POWER-UNIT No. 62A
50V 4·0A D.C. SUPPLY FROM 50HZ. A.C. MAINS

N670
ISSUE F

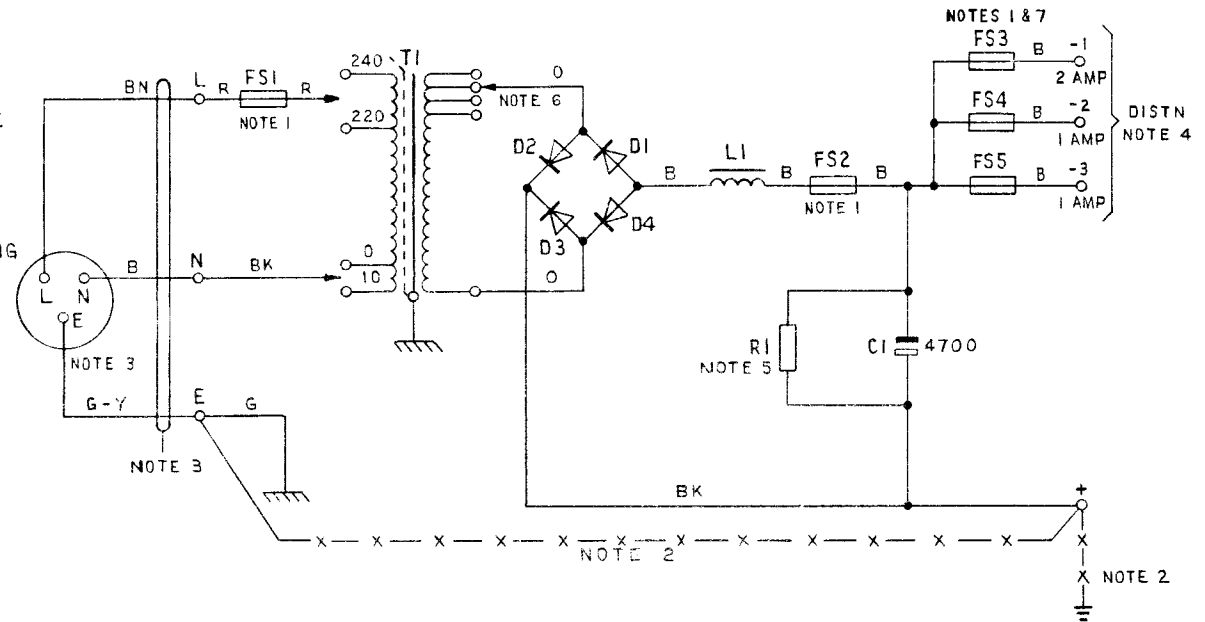
P.O TELECOMMS HQRS			
PAPER:- W	ISSUE	F	NEW FORMAT. TRANSFORMER 200V TAPPING REMOVED. WIRE COLOURS & CAPACITOR VALUE CHANGED. NOTES 2, 3 & 4 AMENDED. NOTE 6 ADDED. DLW TD 7·2·3
DISTN:- GENERAL		E	EARTH WIRE SPECIFIED
			31-1-77
			KMA 7-3-68
